**NSLPP MEETING HELD ON 6/10/21****Attachments:**

ADDRESS/WARD: 5 Earle Street, Cremorne**APPLICATION No:** DA63/2021**PROPOSAL:** Construction of a dwelling house, retaining walls and associated landscaping**PLANS REF:**

OWNER: Jiazhen Tian**APPLICANT:** Rahmani Esan**AUTHOR:** Report of Michael Stephens, Senior Assessment Officer**DATE OF REPORT:** 24 September 2021**DATE LODGED:** 15 March 2021**RECOMMENDATION:** Approval (Deferred Commencement)

DRAWING #: 10	DRAWING NAME: SECOND FL PLAN	SCALE AS SHOWN @ A3		
DEVELOPMENT APPLICATION		PROJECT NO: 20-09	DATE: 23/07/2021	ISSUE C
DRAWN FK	CHECKED ER

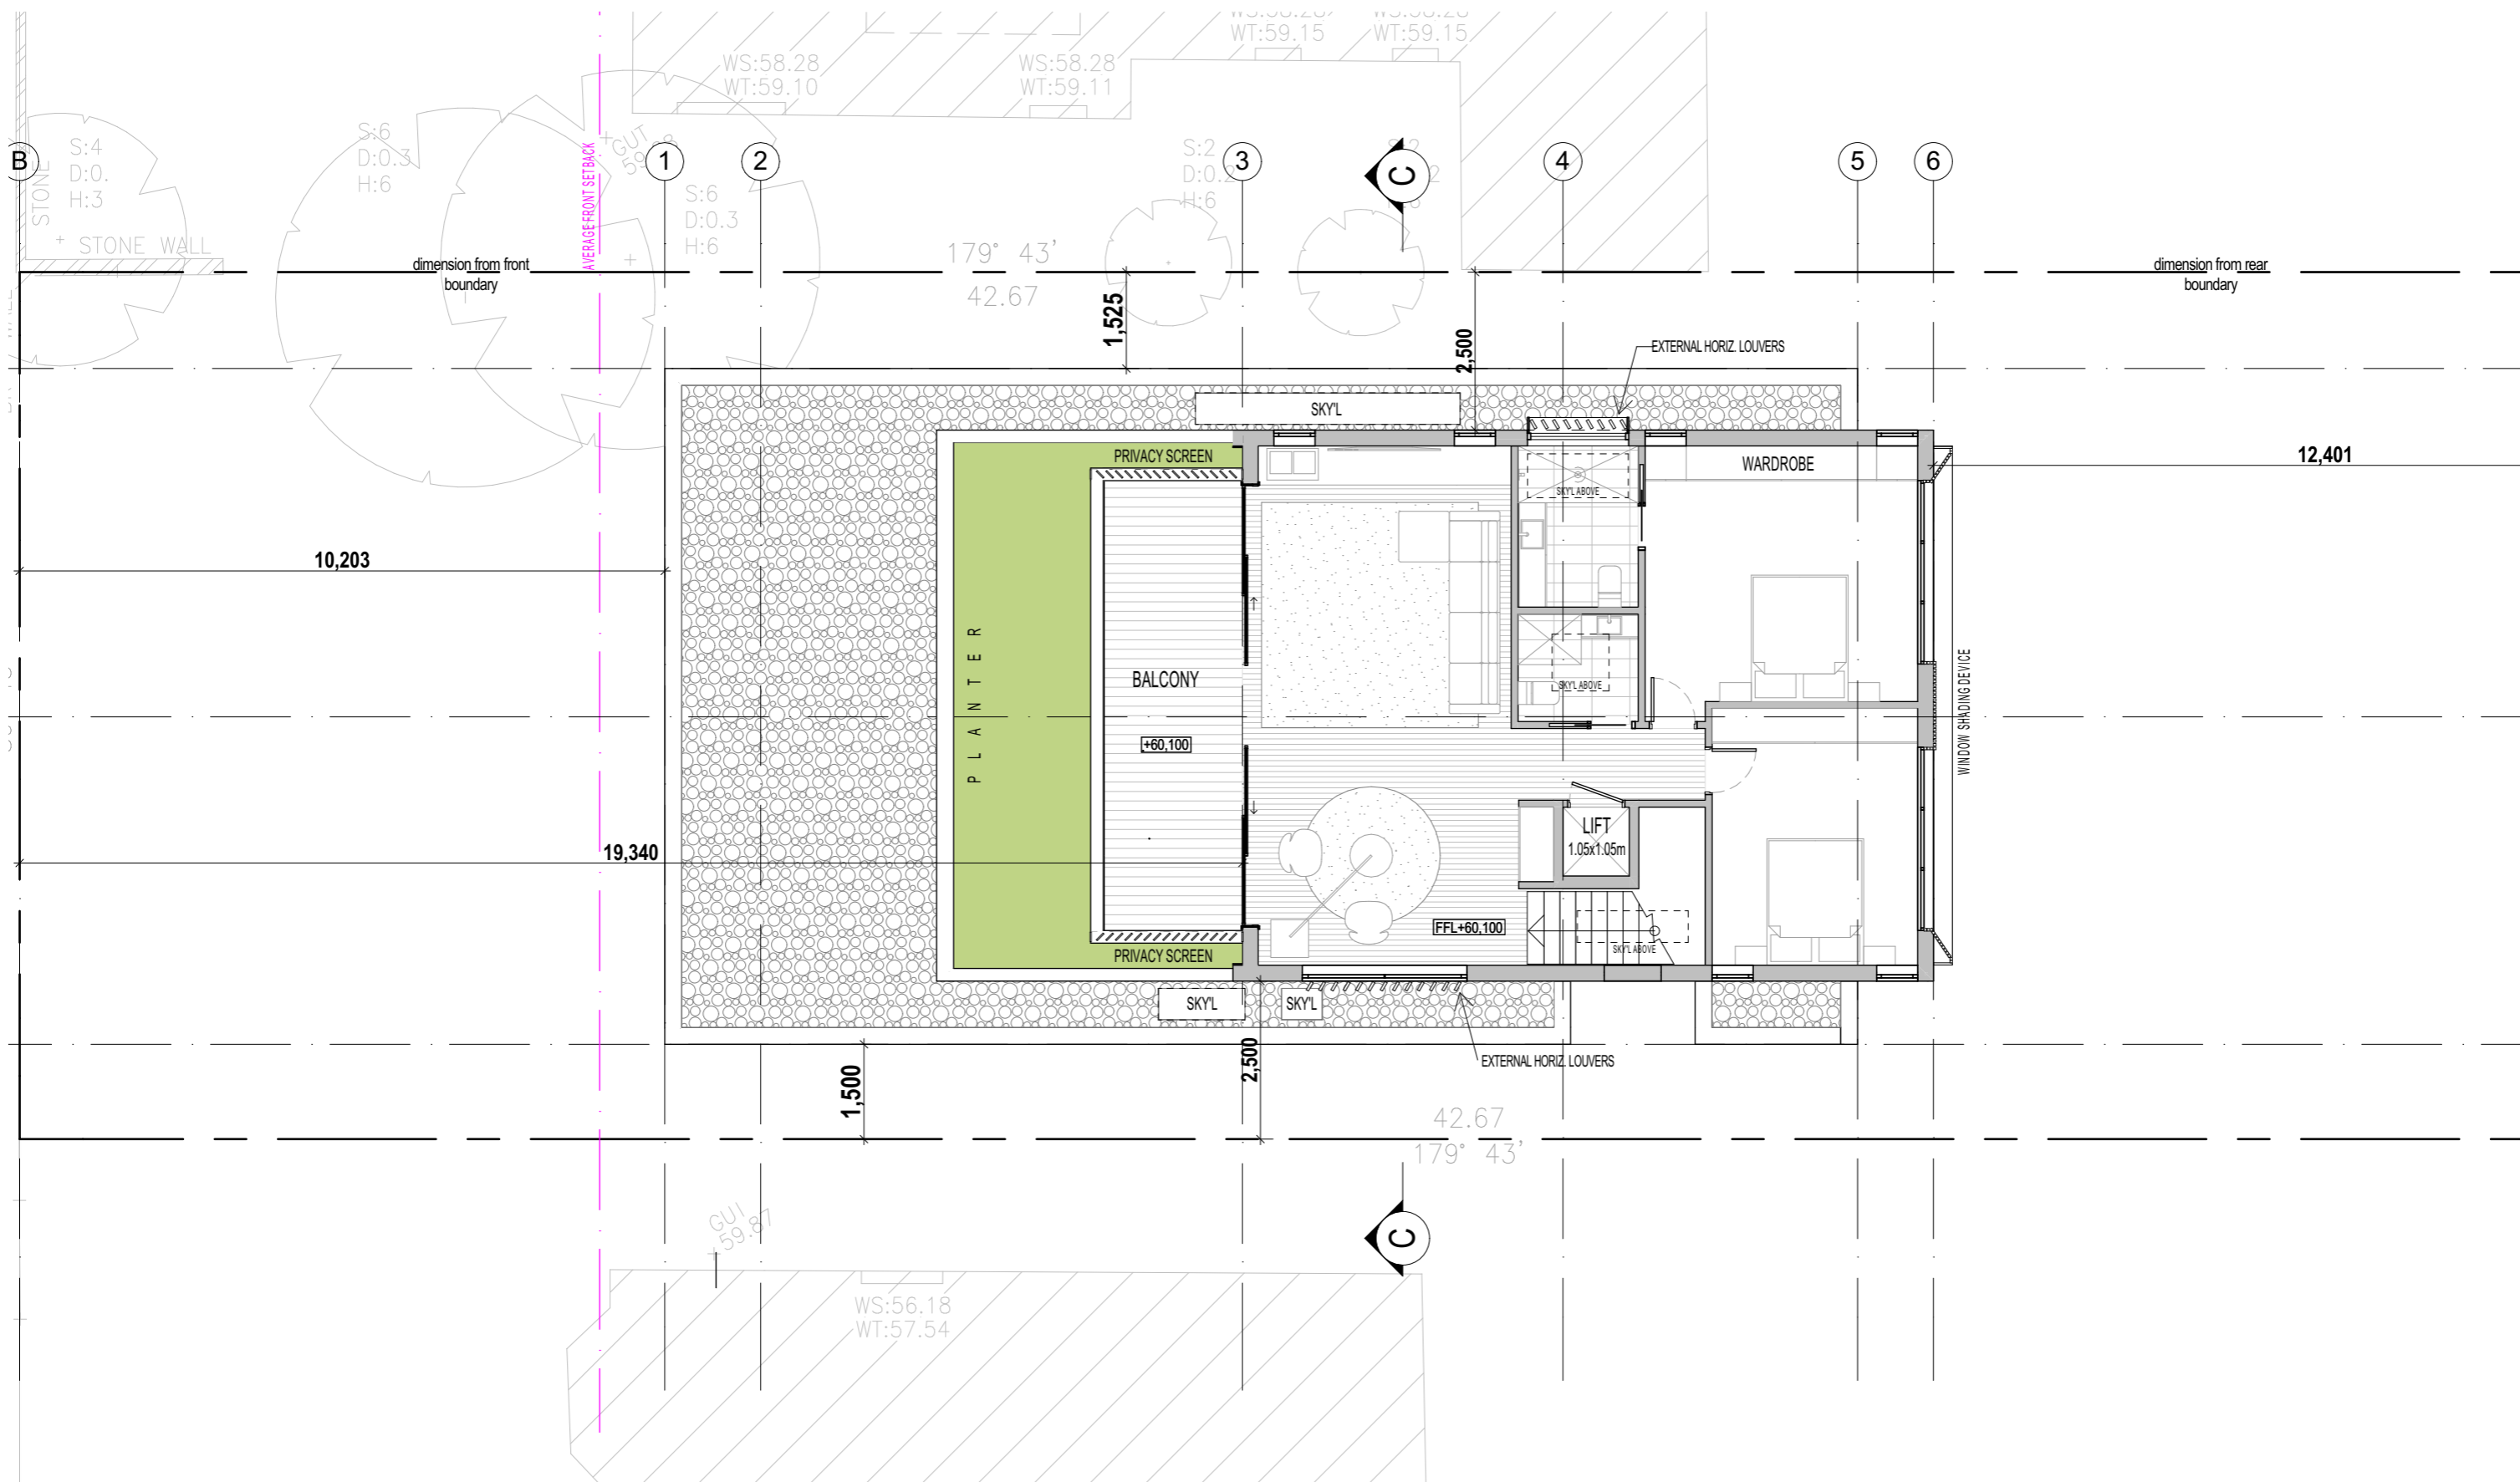
- a. The rear building line of the second floor level (Drawing 10) is to be shifted 800mm to the north to align with the rear building line of the level below. An associated internal replanning to accommodate change may be undertaken.

C27. The landscaped area on the second floor level (Drawing 10 C) surrounding the balcony area is to be demarcated as non-trafficable and is only to be accessible for maintenance purposes.

- I2. The landscaped area of the second floor level (Drawing 10 C) surrounding the balcony area is to be non-trafficable and is only to be accessed for maintenance purposes.
